**STATE OF DELAWARE
EXECUTIVE DEPARTMENT
OFFICE OF STATE PLANNING COORDINATION**

RE: PLUS review – 2012-04-02; Castaways Bethany

Based upon your application you have ask the PLUS reviewers to consider a rezoning of the 38.98 acres from C-1 and MR to C-1, AR, and MR for a proposed RV & Cottage resort with a water park facility.

Figure1: SWMP mapping in the immediate vicinity of the proposed project

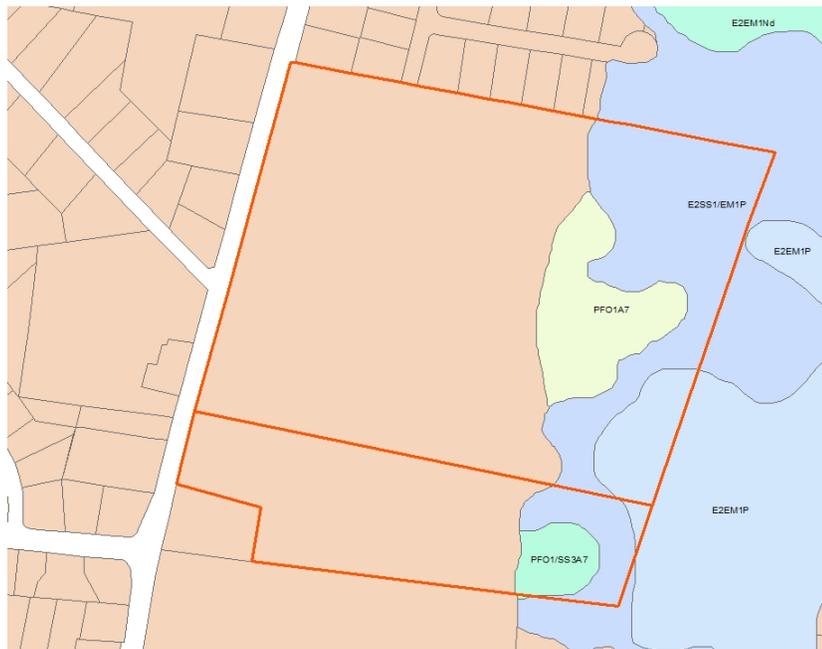
- According to the Statewide Wetland Mapping Project (SWMP) maps, non-tidal palustrine (PF01A7) and tidally-influenced estuarine wetlands (E2SS1/EM1P & E2EM1P) were mapped in the immediate area of the proposed project (See figure 1).

- The applicant is responsible for determining whether any State-regulated wetlands (regulated pursuant to 7 Del.C., Chapter 66 and the Wetlands Regulations) are present on the property. This determination can only be made by contacting the Division of Water's Wetlands and Subaqueous Lands Section at (302) 739-9943 and consulting the State's official wetland regulatory maps, which depict the extent of State jurisdiction. The area regulated by State law may be very different from the area under federal authority. No activity may take place in State-regulated wetlands without a permit from DNREC's Wetlands Section.

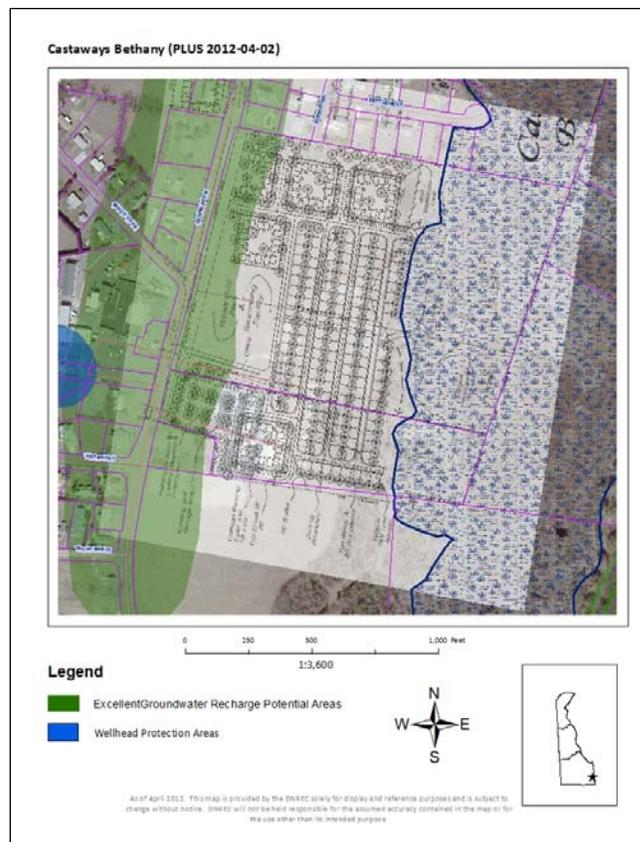
- The western portion of the project falls within an area of excellent ground-water recharge potential for Sussex County (see map).
- The site plan indicates that the water-slide park and swimming facility will be constructed in this area. These facilities and parking pads may require impervious cover. Impervious cover prevents precipitation from infiltrating through the soil to the water table aquifer. Impervious cover refers to structures including but not limited to roads, sidewalks, parking lots, and buildings. Any impervious cover within an area of excellent ground-water recharge potential area has the potential to have a negative effect the quality and quantity of drinking water available.

Land use activities or impervious cover on areas of excellent ground-water recharge potential may adversely affect ground water in these areas.

- Although the Sussex County's Source Water Protection Ordinance meets the minimum standards of protection, this protection does not limit impervious cover in excellent groundwater recharge potential areas. Ground Water Protection Branch recommends keeping impervious cover to less than 35% but no greater than 60% provided the following criteria are met:

- Perform an environmental assessment report showing that *water quality* as well as *water quantity* of post development recharge is equal to or greater than pre-development recharge (Kaufmann, 2005).

- Quantify amount of recharge lost due to impervious cover and provide for onsite infiltration of water at least equal to or greater than pre-development recharge (Kaufmann, 2005).

- Pretreatment of parking area runoff to remove dissolved chemical and nutrient loads prior to infiltration
 - Use Better Management Practices in the design, construction, and maintenance of a storm water management system designed to address water quality with respect to nutrient and other pollutant loads.

Figure 2: Soils mapping in the immediate vicinity of the proposed project area

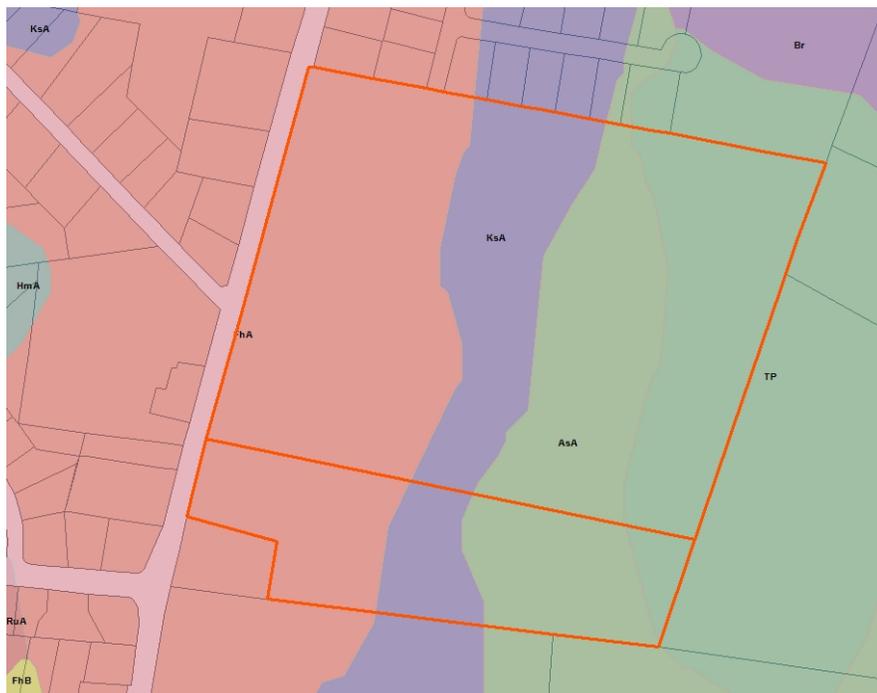
- Based on soils survey mapping update, Fort Mott (FhA), Klej (KsA), Askecksy (AsA) and Transquaking-Mispillion (TP) were mapped in the immediate vicinity of the proposed project. Fort Mott is a well-drained upland soil that has few limitations for development. Klej is a somewhat poorly-drained (transitional soil between uplands and wetlands) soil that may contain both upland and wetland (hydric) soil components. Askecksy and Transquaking-Mispillion are poorly to very poorly-drained wetland associated (hydric) soils that have severe limitations for development and should be avoided - filling and grading these soils may increase the potential for onsite and offsite flooding events (See figure 2).
